ADMINISTRATIVE AMENDMENT (PD) ADD2014-00151

ADMINISTRATIVE AMENDMENT LEE COUNTY, FLORIDA

WHEREAS, Estero Three Oaks Partners, LLC filed an application for an administrative amendment to a Mixed Planned Development on a project known as Estero Oaks MPD to amend the open space calculations for individual tracts, while keeping the overall open space calculations the same, and to request the following deviation:

EXHIBIT "C"

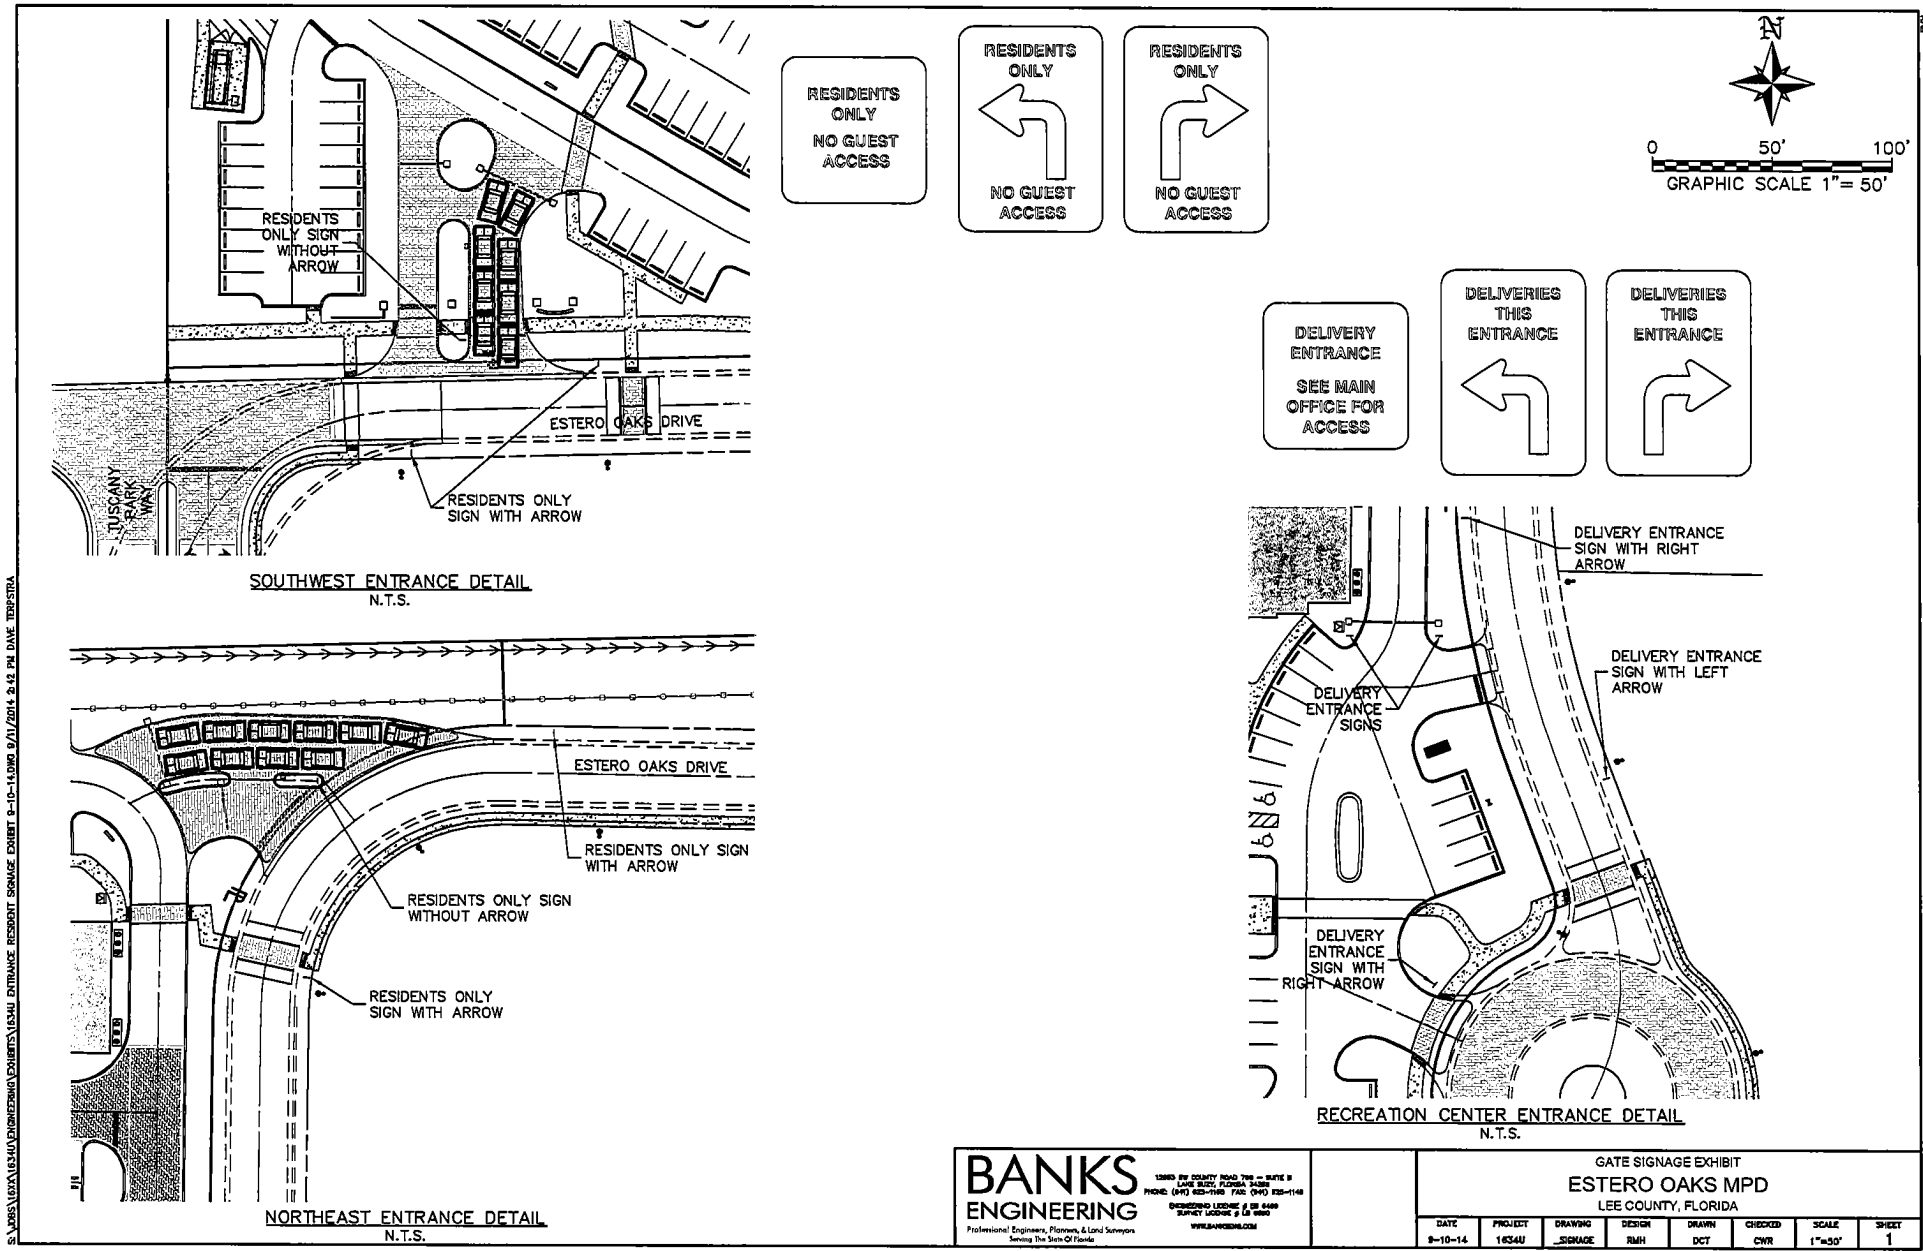
WHEREAS, the applicant is requesting a deviation from LDC Section 34-1748 (5) which requires a paved turnaround, having a turning radius sufficient to accommodate a U-turn for a single unit truck (SU) vehicle to be provided on the ingress side of the gate to allow for a paved turn-around having a turning radius sufficient to accommodate a U-turn for a passenger vehicle for the "residents only" entrance; and

WHEREAS, due to the existing site constraints, it is not practical to provide a turning radius sufficient to accommodate a U-turn for a single unit truck (SU) vehicle but it is possible to provide a paved turn-around having a turning radius sufficient to accommodate a U-turn for a passenger vehicle for the southwestern entrance to the residential tract of the development; and

3. The deviation approved herein is only applicable to the southwest entrance to the residential tract of this development, and must be designed and built in substantial compliance with the plot plan attached hereto as Exhibit "C".

4. Appropriate signage, including "Residents Only" and "No Trucks" signs must be installed at the southwest entrance and direct the visitors and trucks to the main entrance of the residential tract.
